**U.S. Army Corps
of Engineers**
Engineering and Support
Center, Huntsville

**Building L-6822
Fort Bragg, NC**

**POTR – Phase 1
Project No 54912**

March 28, 2012

REVISED SITE DESIGN
FT. BRAGG
DR. ENGINEERING GROUP
SCALE: 1"=60' DATE: 4-20-09

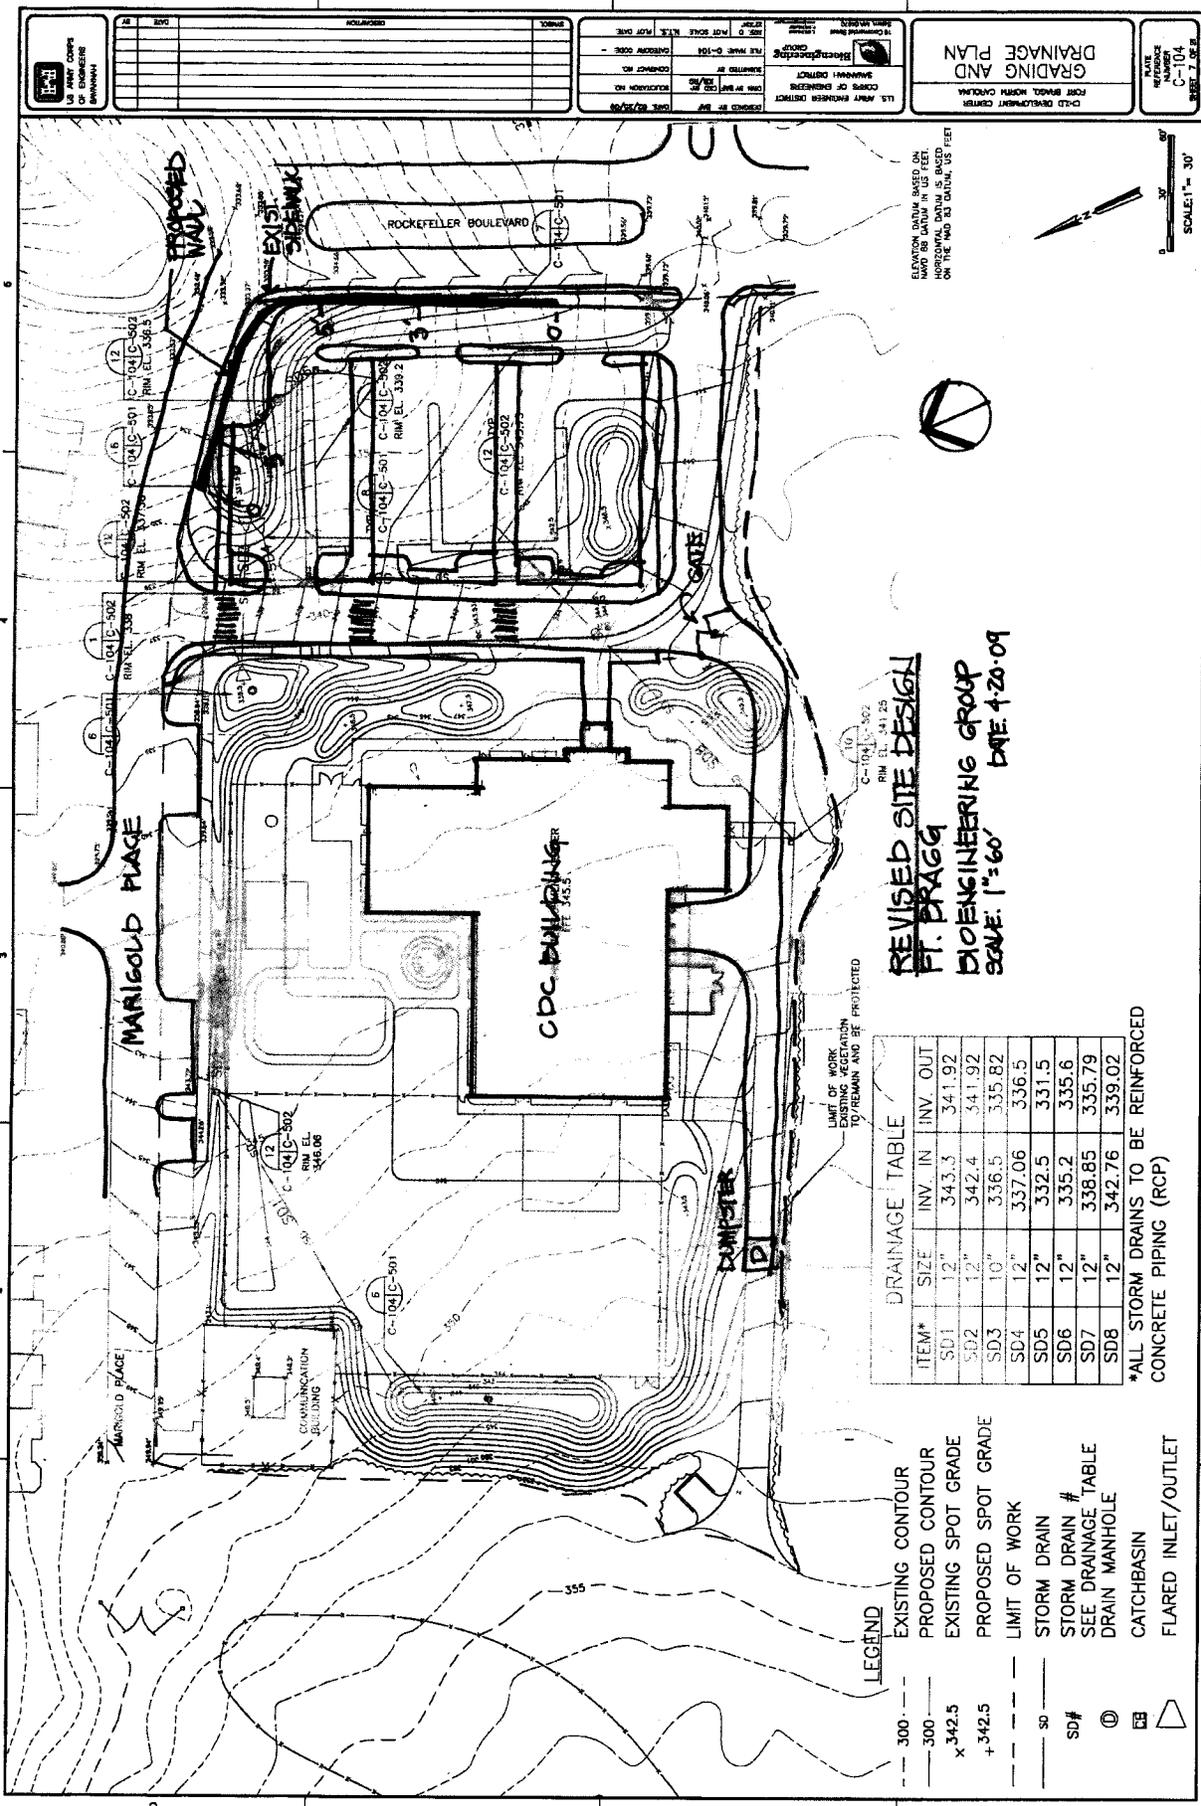
Revise 100% site design documents to relocate the 26 staff parking spots shown on Marigold Place into the main parking lot for the CDC, and relocate the service entrance road from the Gordon Elementary bus loop to an acceptable location coming off of Rockefeller Blvd.

Drawing C-104 Revise Sheet C-104 (Plate 07) with updated parking lot and service road design. Add plate(s) to incorporate retaining wall. It is understood and agreed that the contract drawings affected by this Modification will be updated to reflect as-built conditions necessitated by this change, and that cost for such updates are included within this Modification amount.
